AR-07-1162

Southern Nuclear Operating Company
Vogtle Early Site Permit Application
Supplemental Response to Requests for Additional Information on Geology/Seismology

**Supplemental Response to Geology/Seismology RAIs
on the
Vogtle ESP Application**

Figure 1a. Quadratic fit to the amplification values for 100 Hz.

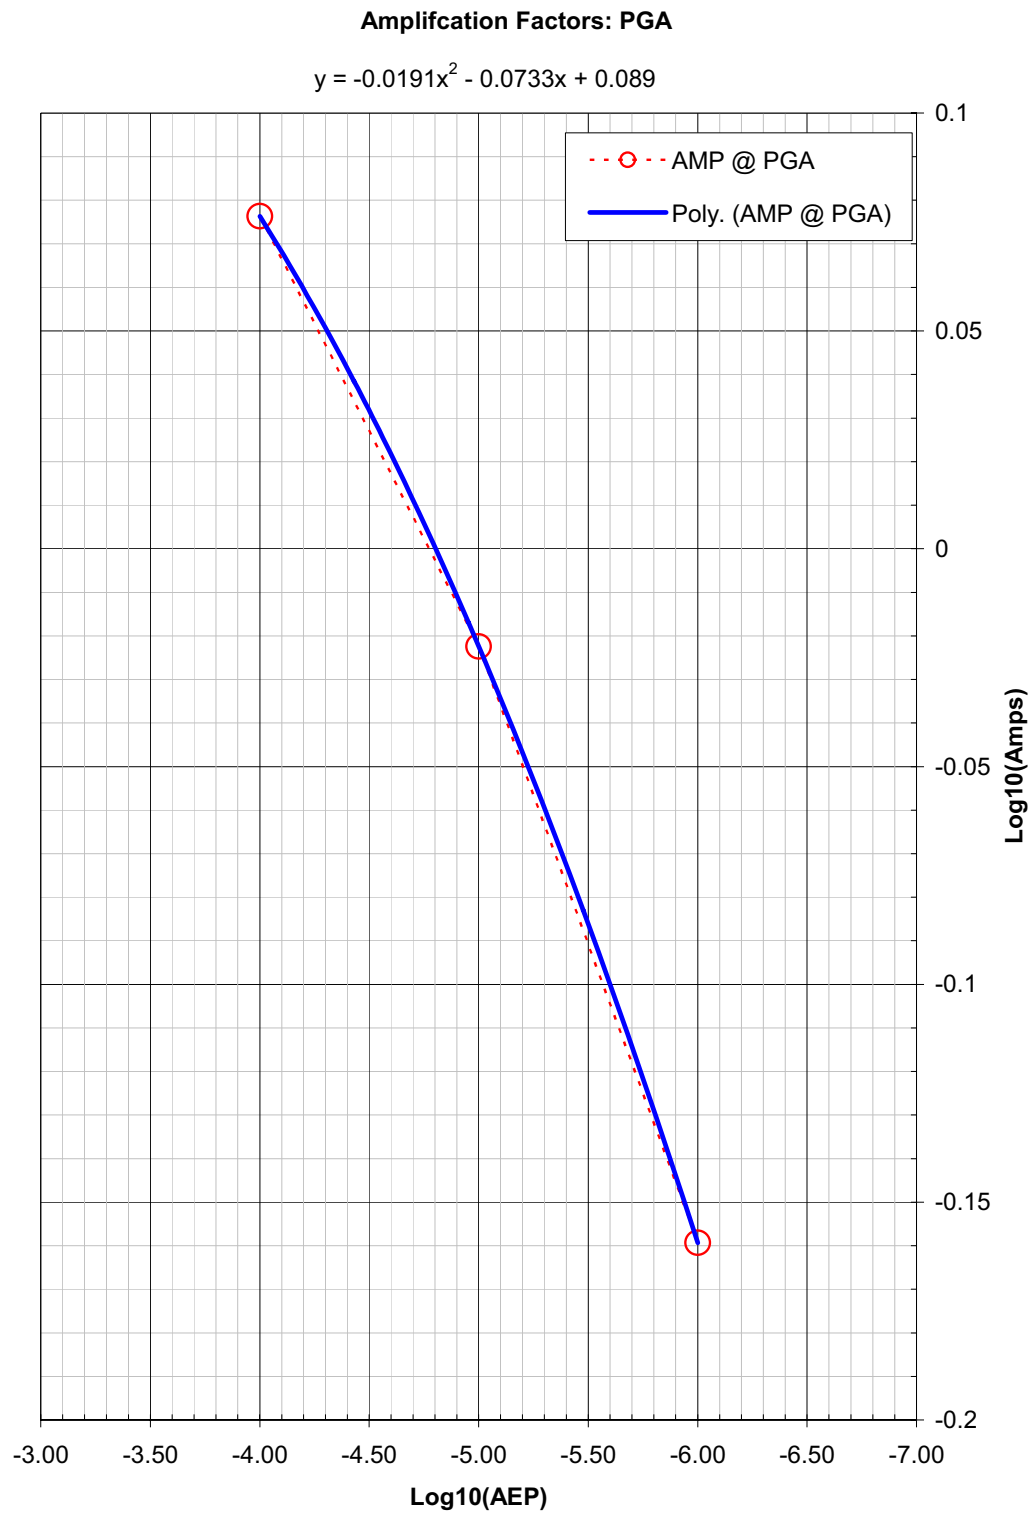
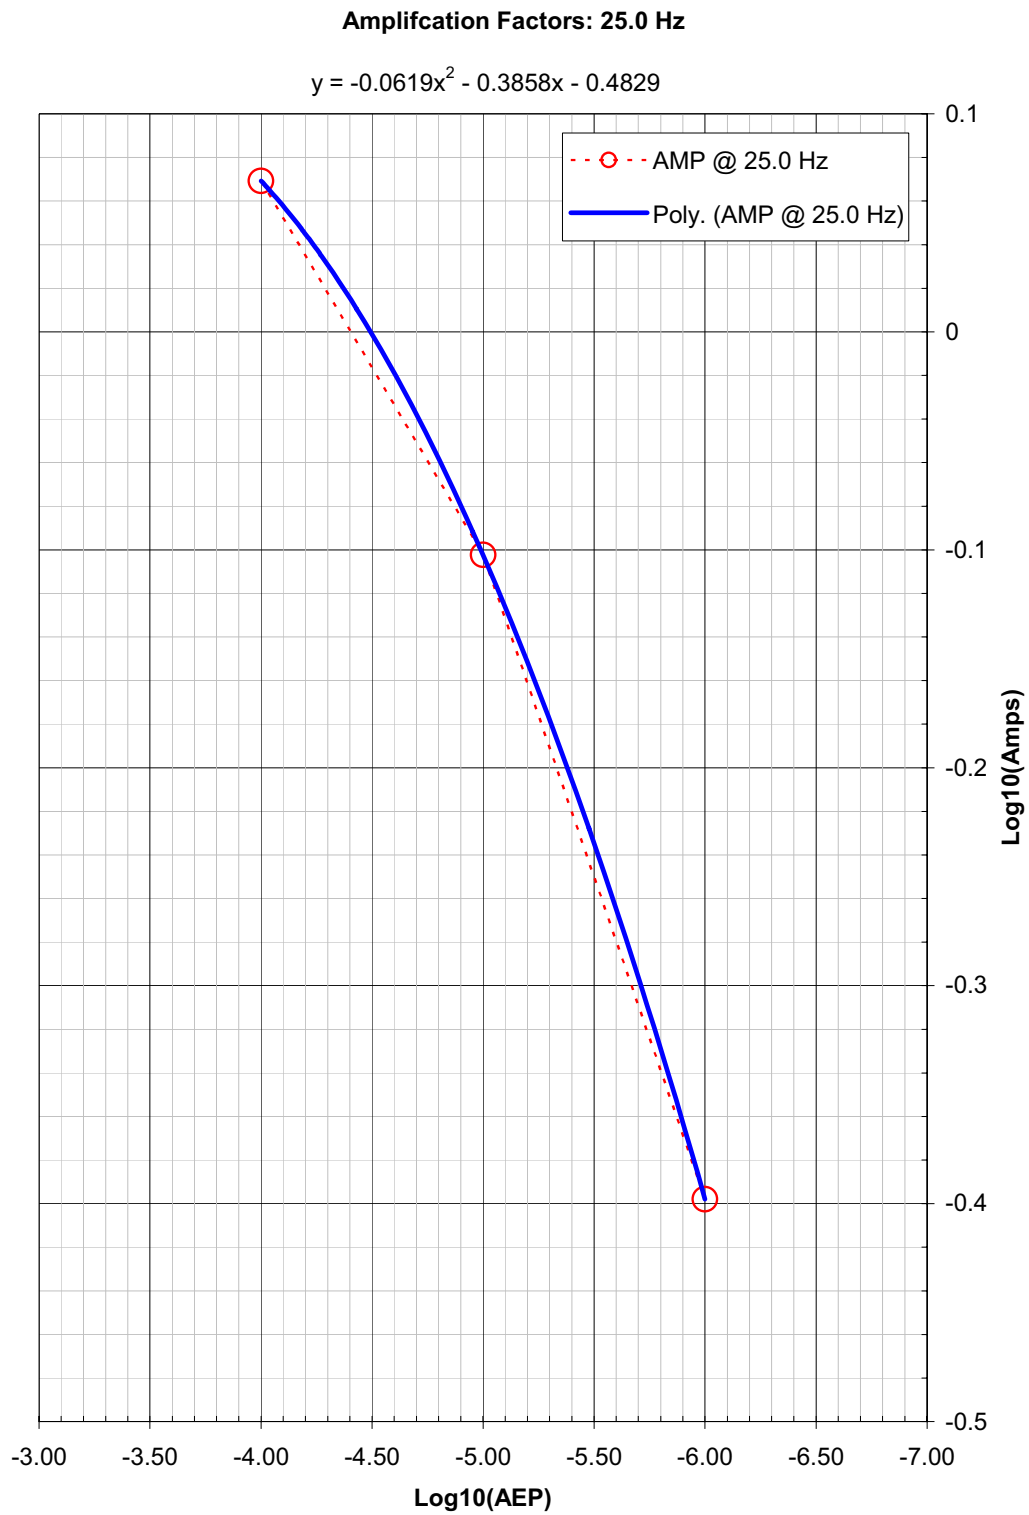
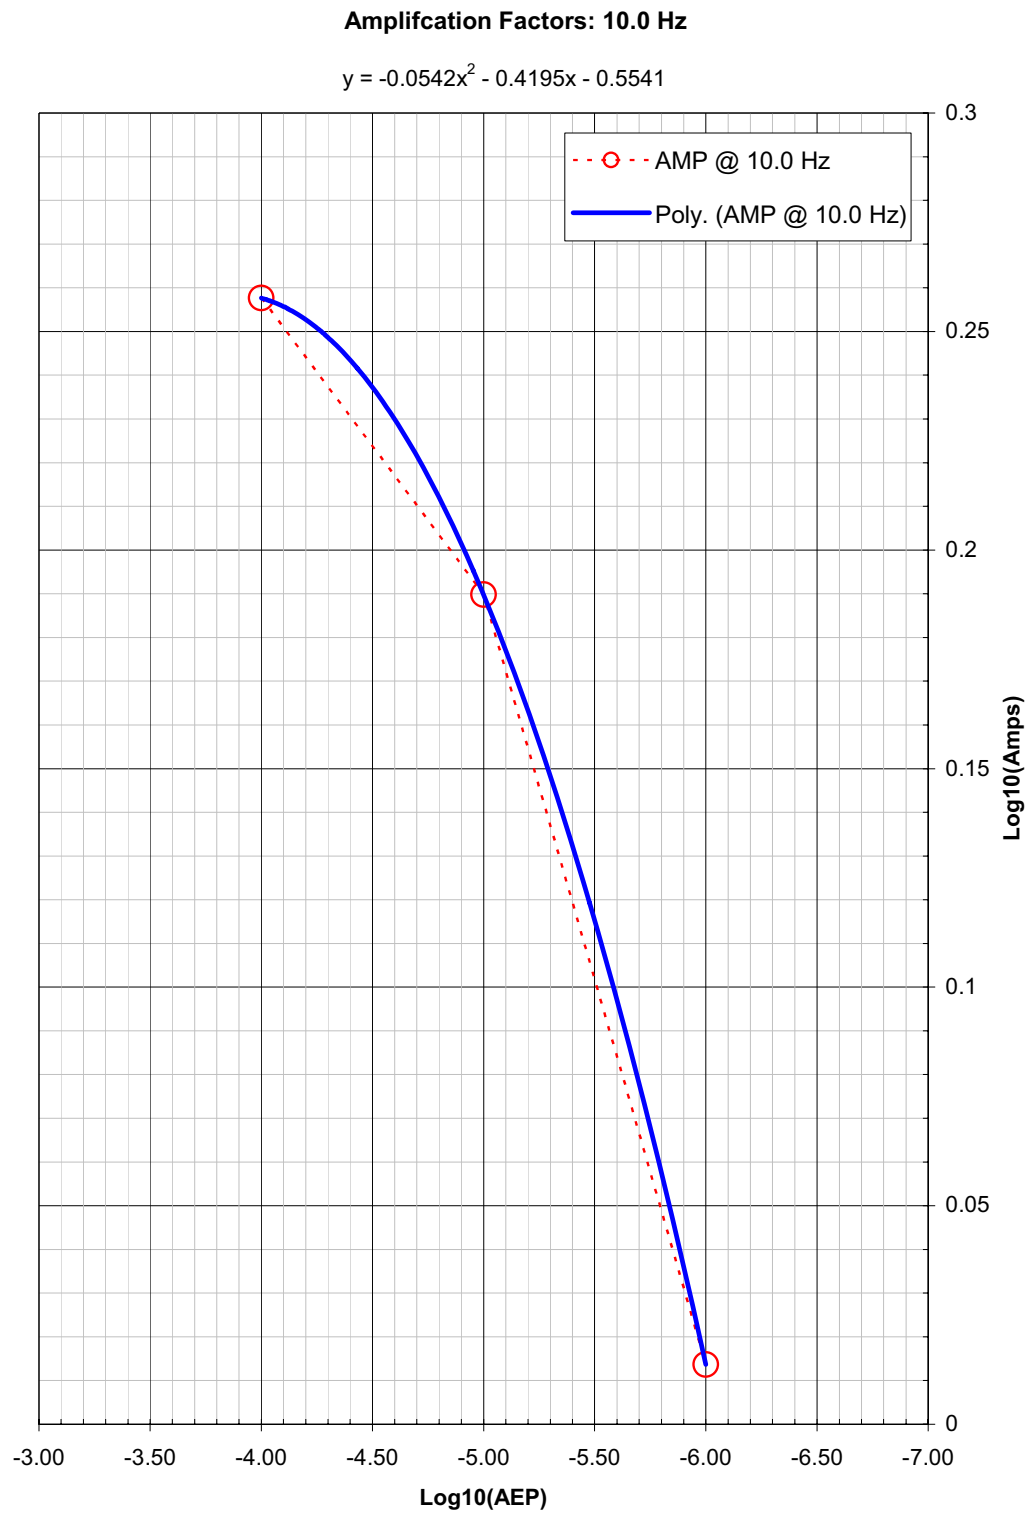
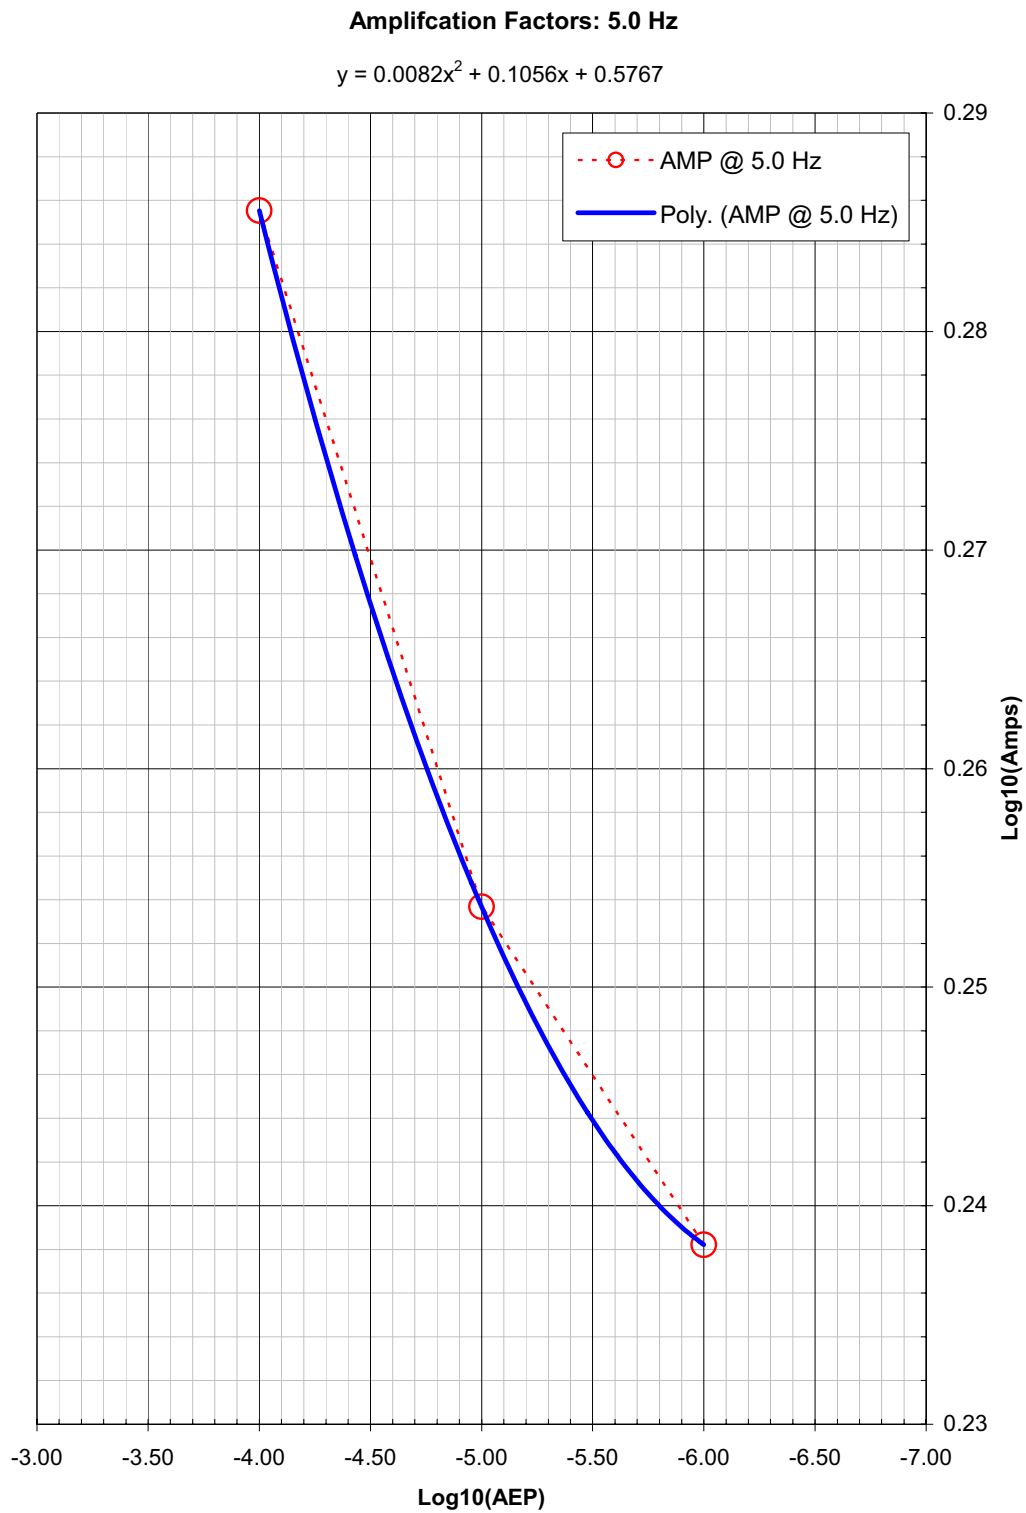
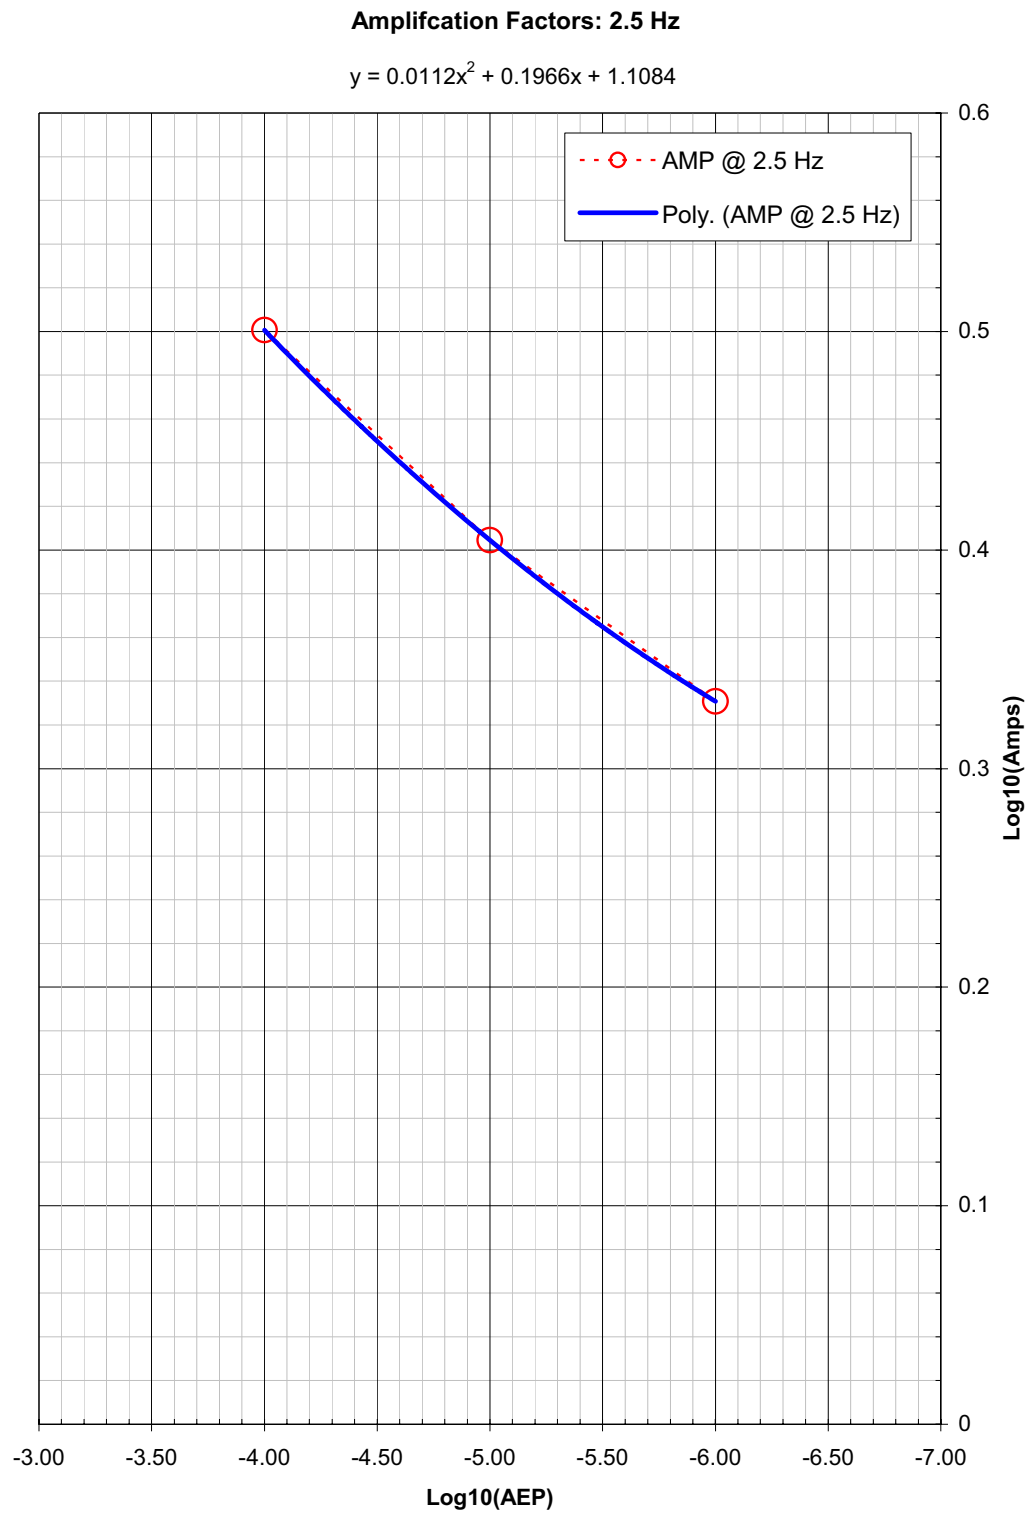
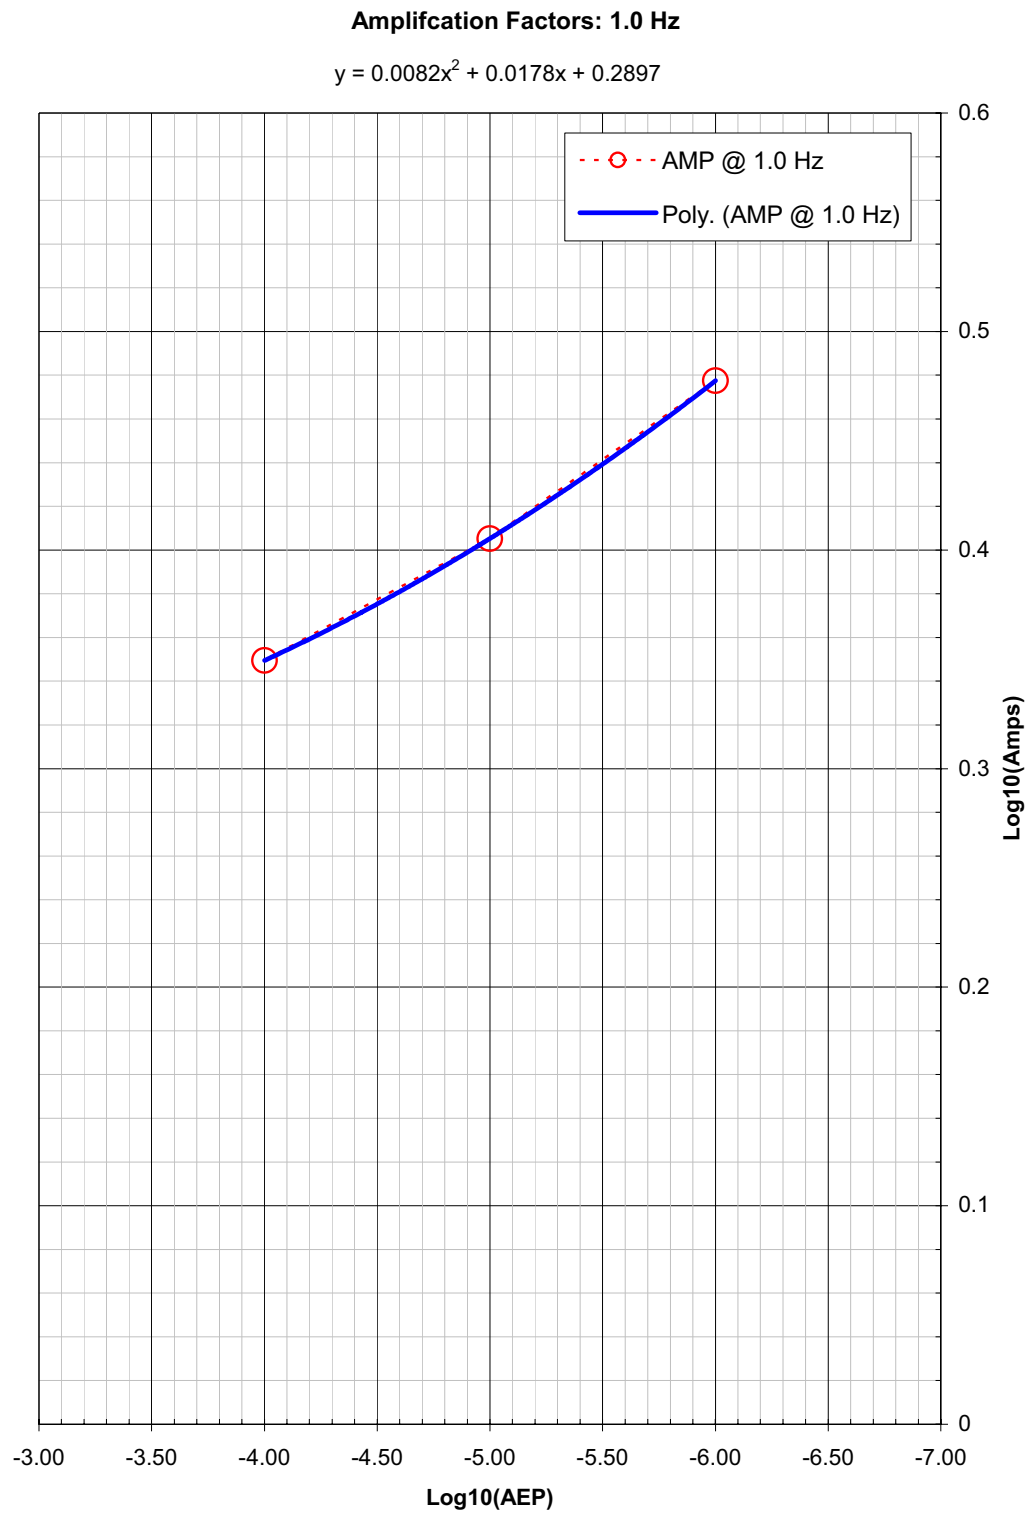
2.5.2-3 In response to this RAI, soil hazard curves were provided at three annual exceedence frequencies (10^{-4} , 10^{-5} , and 10^{-6}). However, in order for the staff to verify the adequacy of the SSE, soil hazard curves are requested at additional annual exceedence frequencies (i.e. at values between 10^{-4} , 10^{-5} , and 10^{-6}).

For each of the seven frequencies a quadratic equation was fit to the log (base10) of the spectral ratios (AMP) as a function of the log (base10) of the annual exceedence probability (AEP). Mathematically, this functional model is given as,

The resulting fits to the three data points are shown in Figure 1, located on the following pages, for each of the seven frequencies. The coefficients and equation are given at the top of each plot. Note that the red dashed line is a linear log-log line between the three data points.
